RE: Termination Request  
NMOCD Case #: 1R425-64  
Vacuum F-25 EOL Site, T17S, R35E, Section 25

**From:** Katie Jones  
**To:** "Edward J. EMNRD Hansen"  
**Cc:** Hack Conder; "Katie Lee"  
**Subject:** Vacuum F-25 EOL (1R425-64) CORRECTED CAP Addendum  
**Date:** Thursday, May 05, 2011 10:07:00 AM  
**Attachments:** Vacuum F-25 EOL Proposed liner.jpg

This email is a Corrected Addendum to the Vacuum F-25 EOL site (1R425-64) Corrective Action Plan, submitted to the NMOCD November 24, 2010. Page 1, second paragraph: text in blue lettering, below, will be added to the paragraph. Red lettering marked with a strike-through will be deleted. The new plate 4 showing the proposed liner location is attached. If you need any further information, please let me or Hack know.

## Plate 4

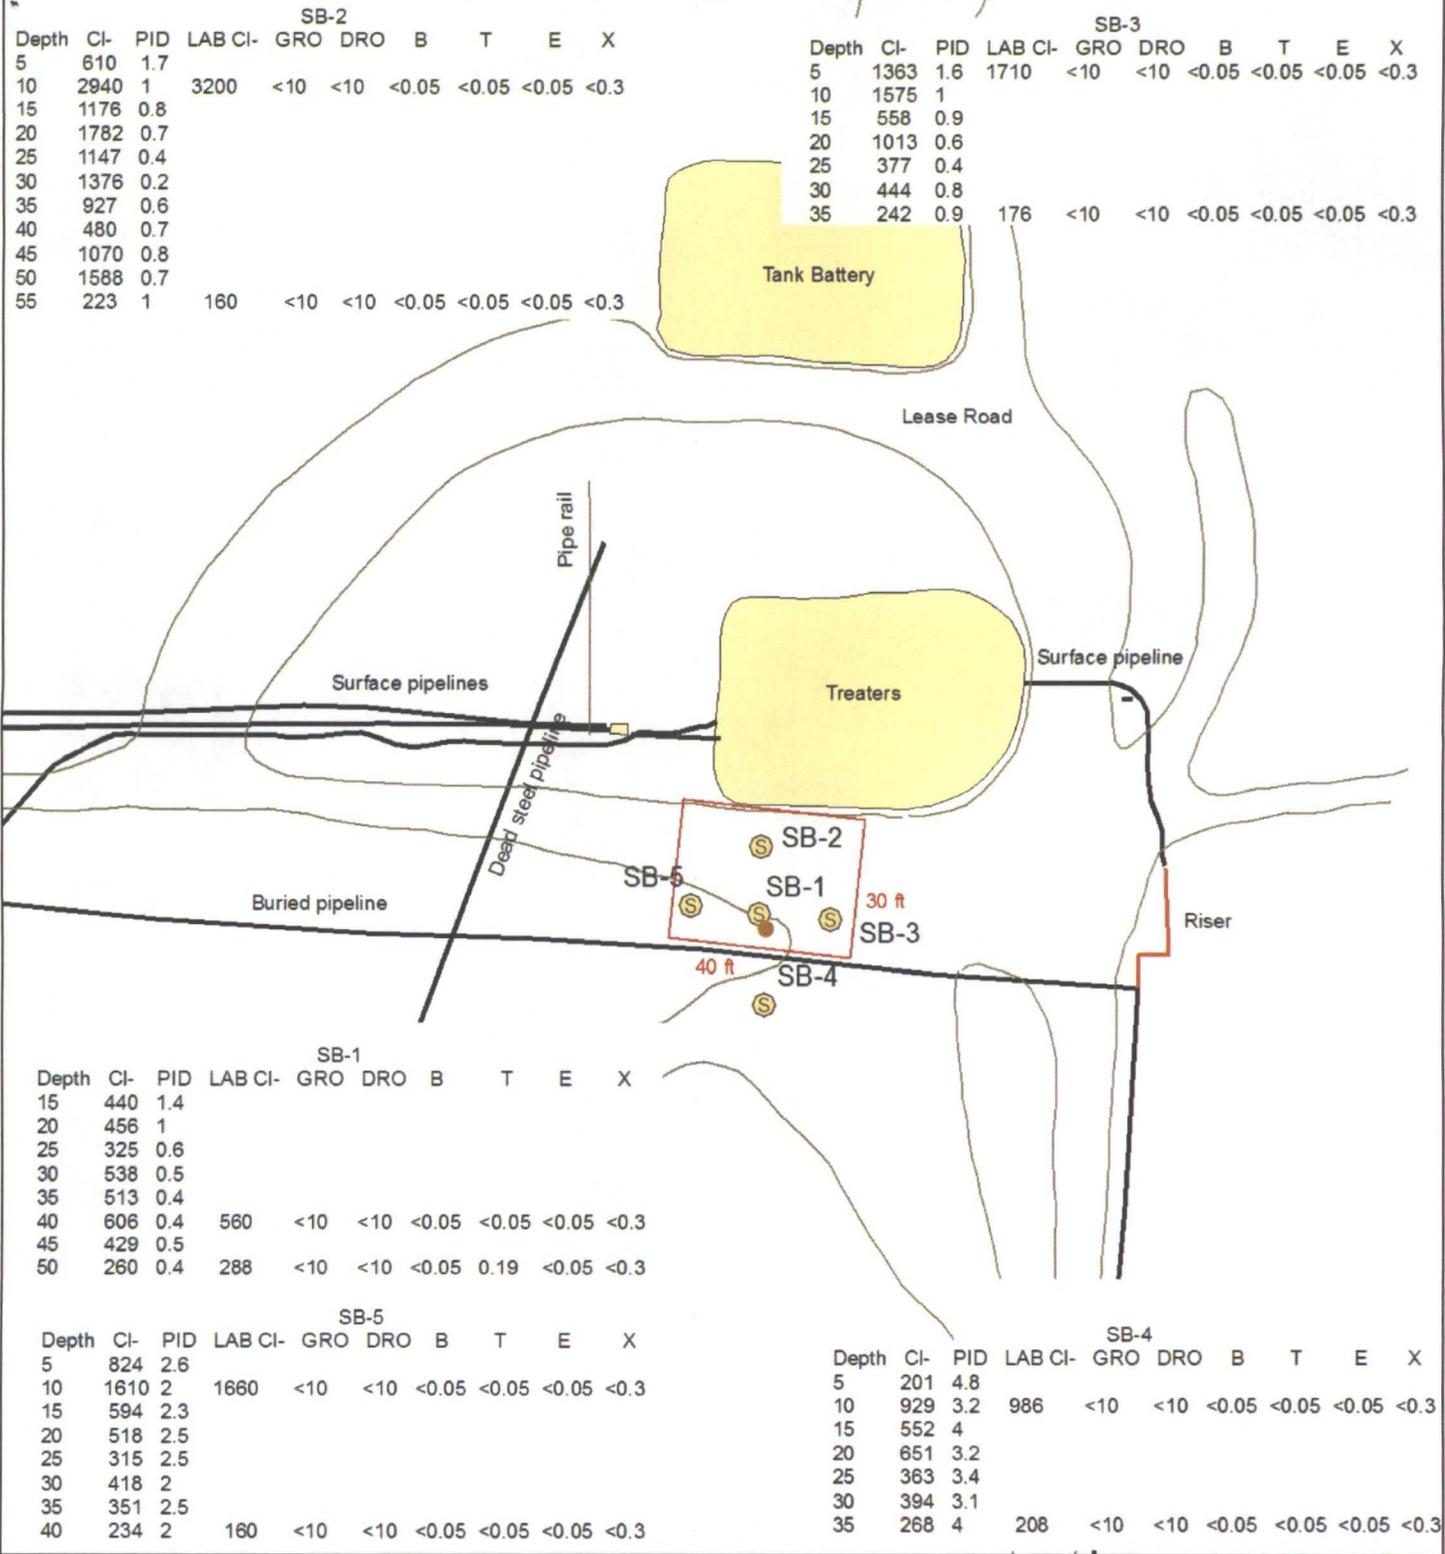
"Our recommended corrective action for the site is the installation of a 30 x 40~~30~~ foot synthetic liner 4-5 feet below ground surface as seen at the attached Plate 4~~centered over the former site~~ and re-vegetation of the backfilled area~~an area 45 x 45 feet in size~~ above the former site. This design meets the mandate of NMOCD Rules for protection of surface water, ground water and the environment. The investigation demonstrates that with this remedy in place residual chloride and hydrocarbons in the vadose zone will not with reasonable probability contaminate ground water or surface water in excess of the standards in Subsections B and C of 19.15.30.9 NMAC through leaching, percolation or other transport mechanisms, or as the water table elevation fluctuates."

- Installation of a liner at a depth of four-feet underneath the 30-foot by 40~~30~~-foot area centered over the former site. Excavated soil will be evaluated for use as backfill above the liner. All backfill material will contain a chloride concentration below 500 mg/kg and PID (field parameter) reading less than 100 ppm. Any soils requiring disposal will be properly disposed of at an NMOCD approved facility. ~~Clean fill (with a chloride concentration below 500 mg/kg and PID (field parameter) reading less than 100 ppm) will be imported to replace excavated material above the liner.~~

- Upon completion of the liner installation, the lease road will be repaired and the surrounding backfilled area will be seeded with native vegetation~~re-vegetate a 45-foot by 45-foot area centered east-west over the former excavation and adjacent to the road on the north to reduce infiltration~~ (see Plate 4).

"The remedy design for the site is the installation of a 30' x ~~30~~40 foot synthetic liner 4-5 feet below ground surface centered over the former site and re-vegetation of the backfilled area ~~an area 45 x 45 feet in size~~ above the former site. Our recommended corrective action meets the mandate of NMOCD Rules for protection of surface water, ground water and the environment. The investigation demonstrates that with this remedy in place, residual chloride and hydrocarbons in the vadose zone will not with reasonable probability contaminate ground water or surface water in excess of the standards in Subsections B and C of 19.15.30.9 NMAC through leaching, percolation or other transport mechanisms, or as the water table elevation fluctuates. Upon documentation of installation of the liner and re-seeding of the site with an appropriate mix of native grasses we will submit a Termination Request for this site's regulatory file."
